Office Action Summary	Application No. 10/790,916	Applicant(s) KOCH, STEVE GEORGE	
	Examiner Vishal Patel	Art Unit 3676

Title: Seal Feature to Prevent Bending

Serial No.: 10/790,916

1/4

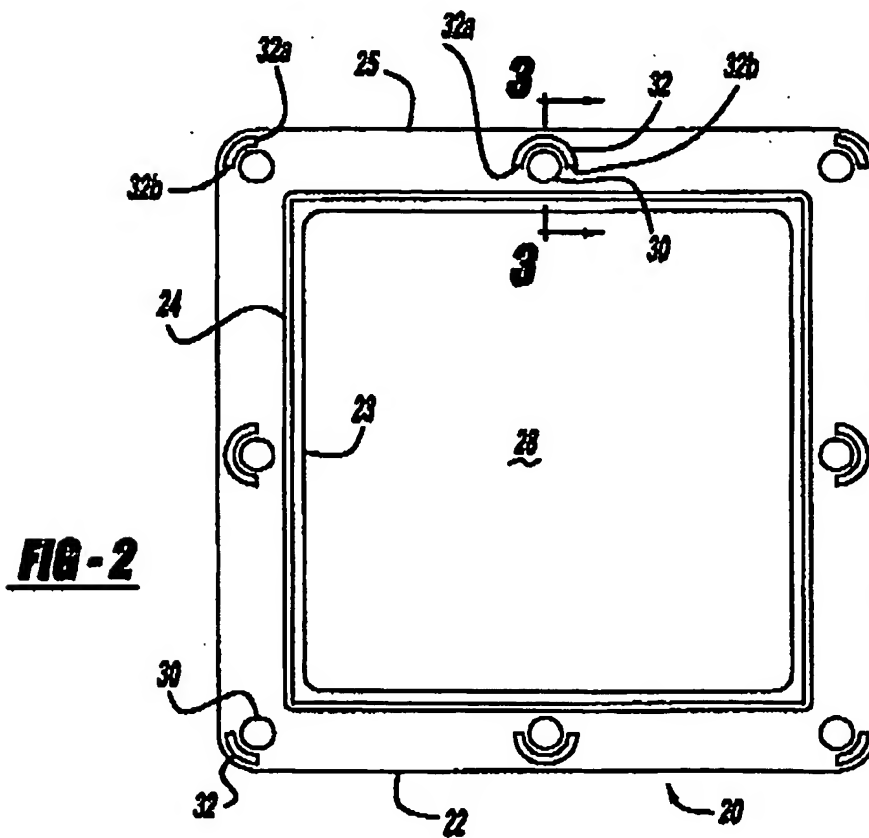
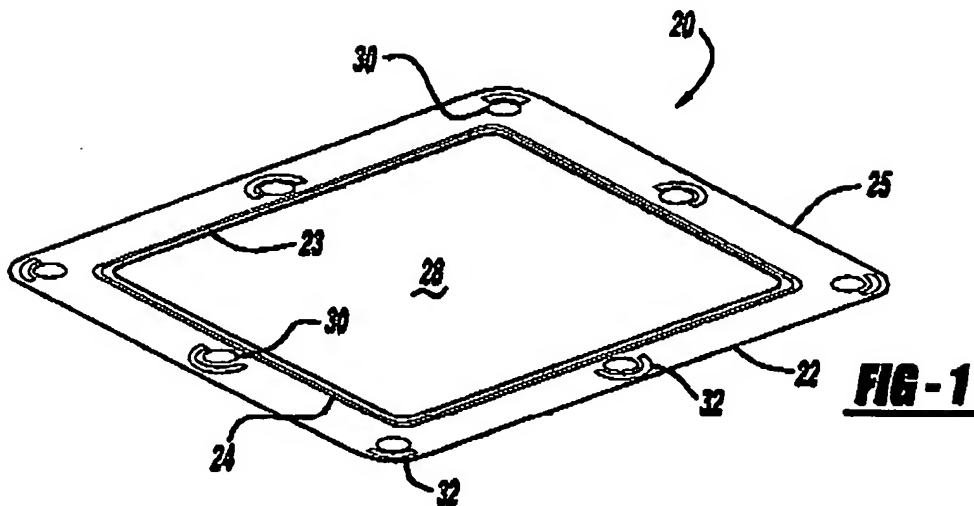
APPROVED, VP 4/6/05
